CITY COUNCIL
DATE: 10/15/19

AGENDA ITEM: **Easement Vacations and Minor Subdivision – Outlot O of Inwood Addition (Inwood 6th Addition)**

PRELIMINARY PLAT

Re: Inwood 6th Addition – Kwik Trip
Preliminary Plat Review

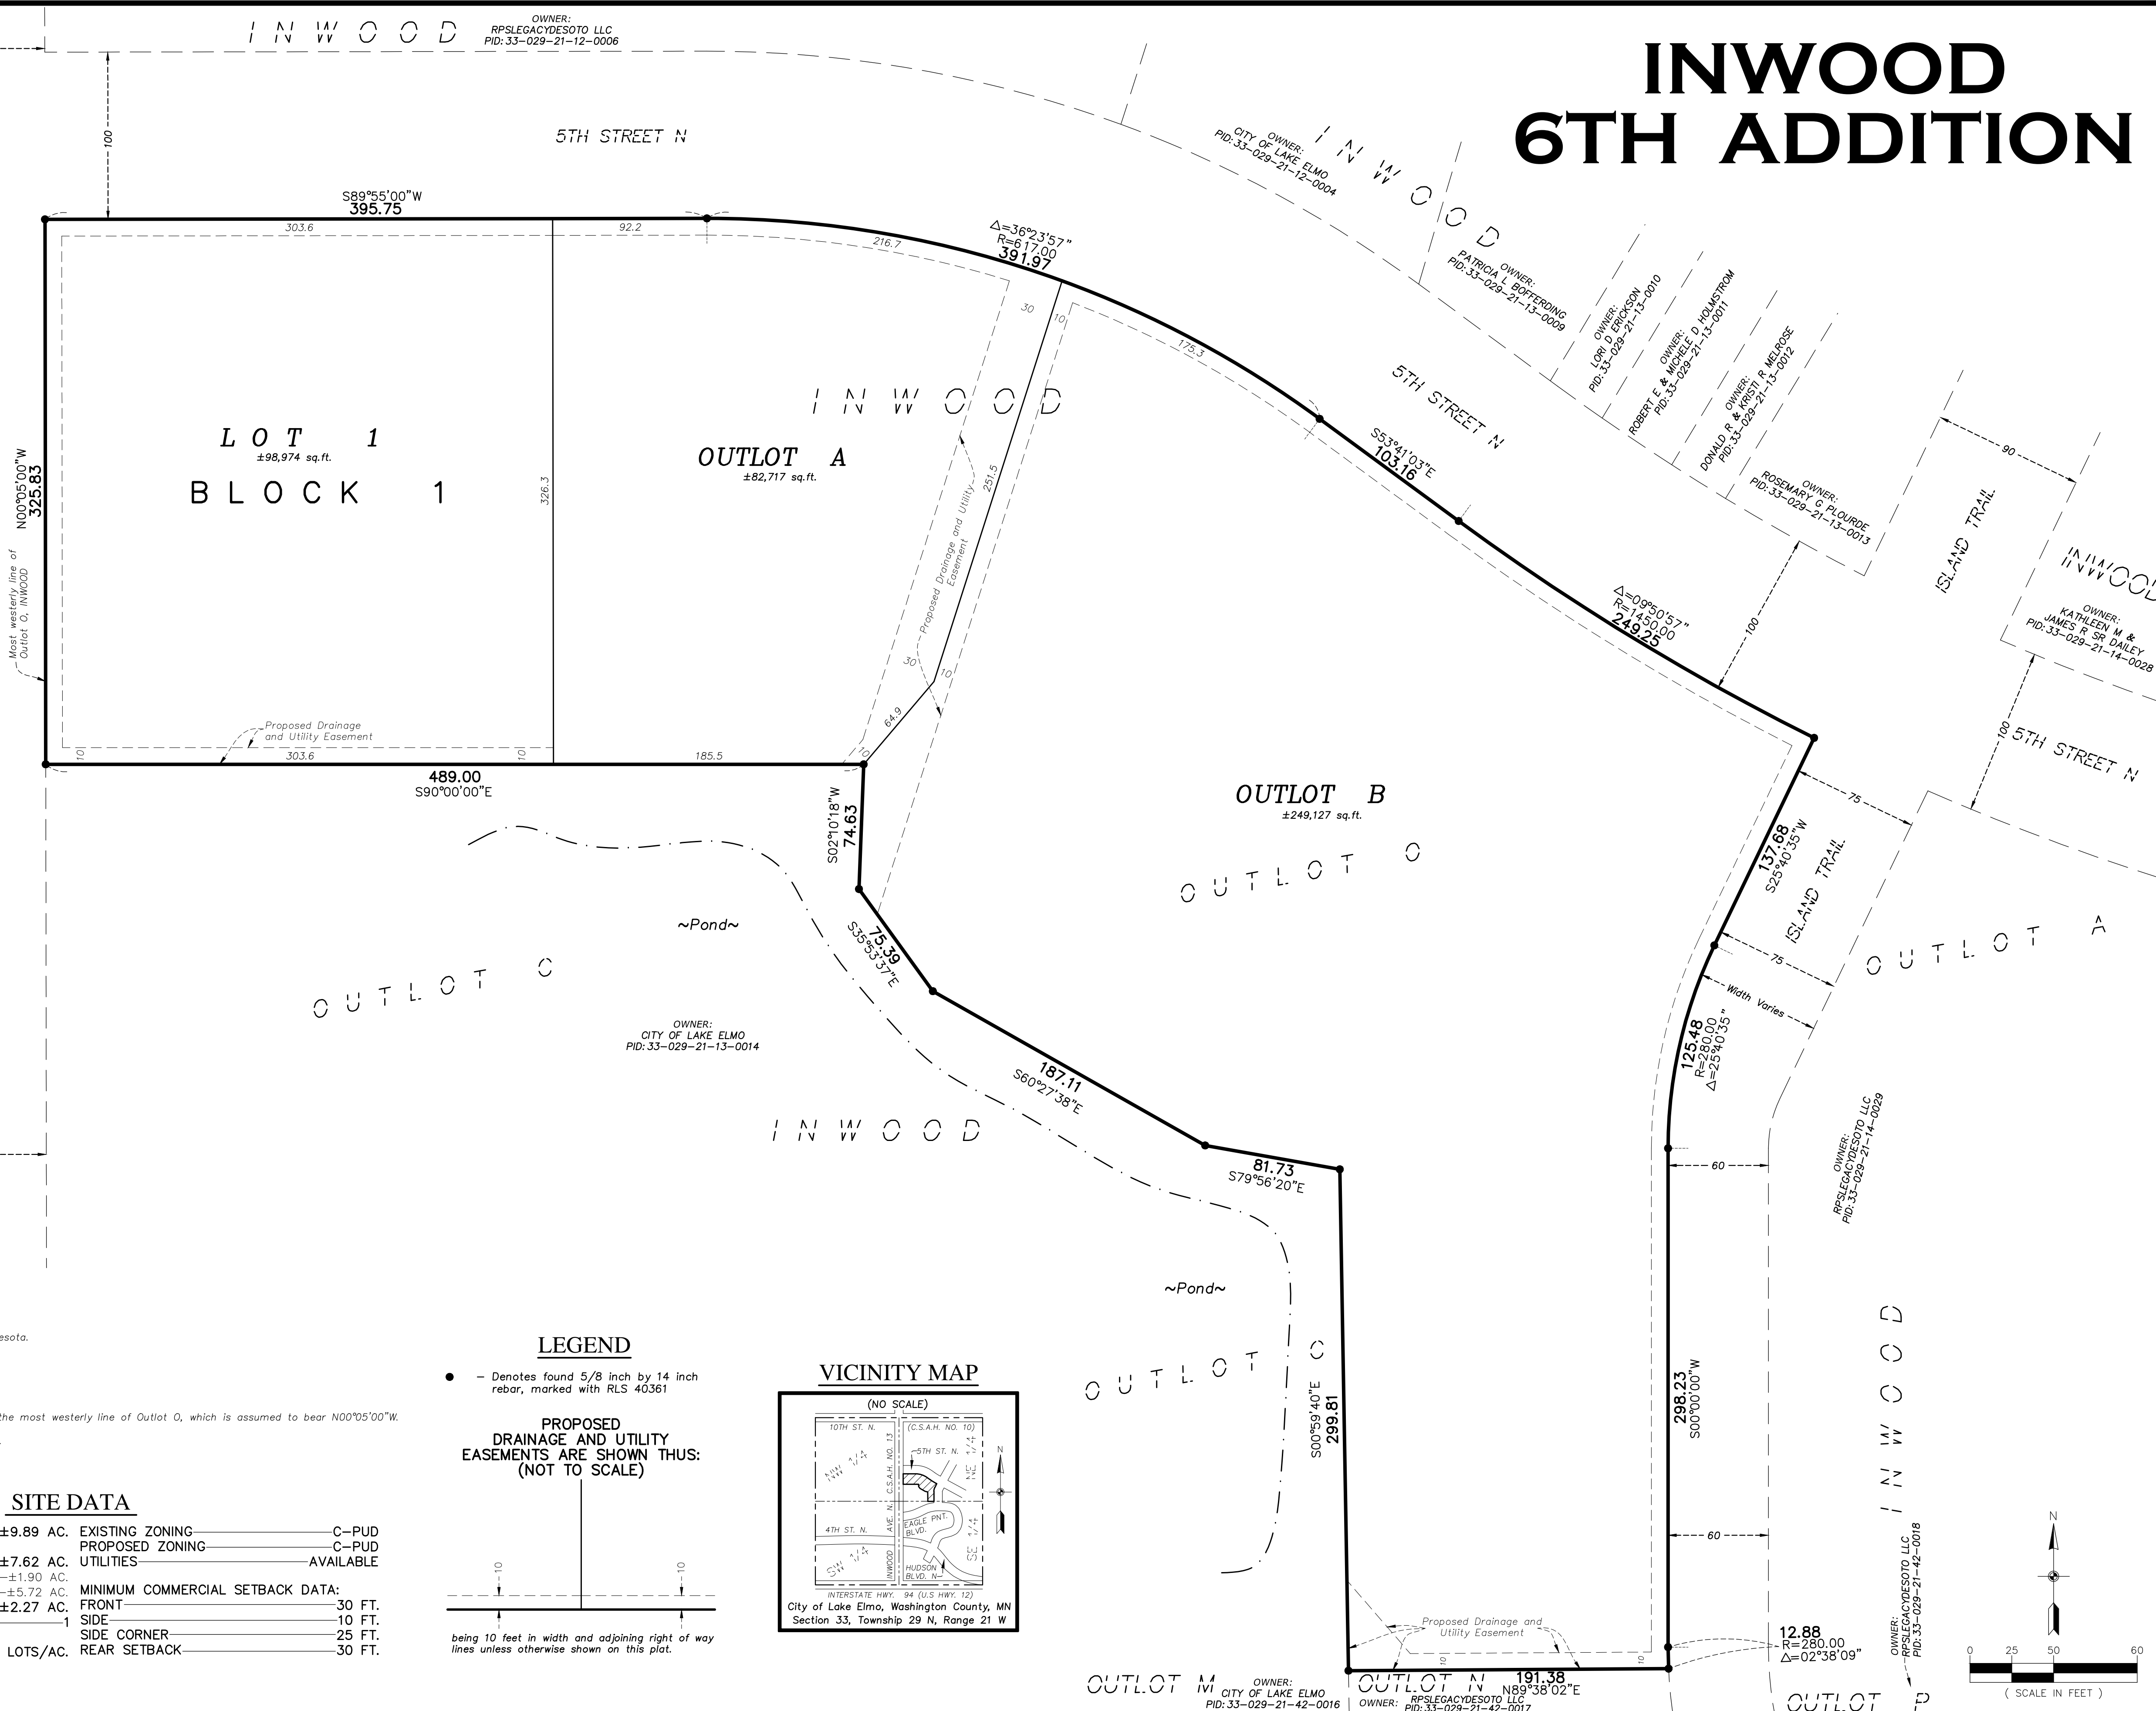
1. Outlot ownership should be identified on the Preliminary Plat and on the Preliminary Plans. Outlots A and B should be shown as Developer owned.
2. Lot lines and easements are not shown consistently between the Preliminary Plat and the Preliminary Plans. The plans must be revised to accurately reflect the proposed plat. The lot lines and easement locations may be subject to revision once they can be accurately reviewed with respect to the proposed improvements.

3. Drainage and utility easements must be provided for any public utilities constructed as part of the project, including City owned watermain and hydrants, with the easements shown on the preliminary plans.

4. Consideration should be given to adjusting the east lot line of Outlot A further west to facilitate a shared commercial driveway access between Outlot A and Outlot B. See comment #3 below for Site Plans, Traffic and Access Management.

- The Preliminary plat and project plans should be revised to show the proposed lot lines and easements consistent on each set of plans.
- Drainage and utility easements must be provided for any public utilities constructed as part of this project, including City-owned watermain and hydrants, with easements shown on the plat and on the project plans. Any watermain lines serving hydrants placed internal to the site require minimum 30-foot-wide easements centered over the hydrants and pipe. These easements must be dedicated to the City and be provided in the City's standard form of easement agreement.

- The developer/owner should consider adjusting the east lot line of Outlot A further west to facilitate shared commercial driveway access between Outlot A and Outlot B. As proposed, Outlot B would not have access to the new driveway along the east side of Outlot A as there would be a strip of land as part of Outlot A along the east side of the driveway.

3. The final plat shall show a 10-foot-wide drainage and utility easement along all property lines.
4. All easements as requested by the City Engineer and Public Works Department shall be documented on the Final Plat before the execution of the final plat by City Officials.
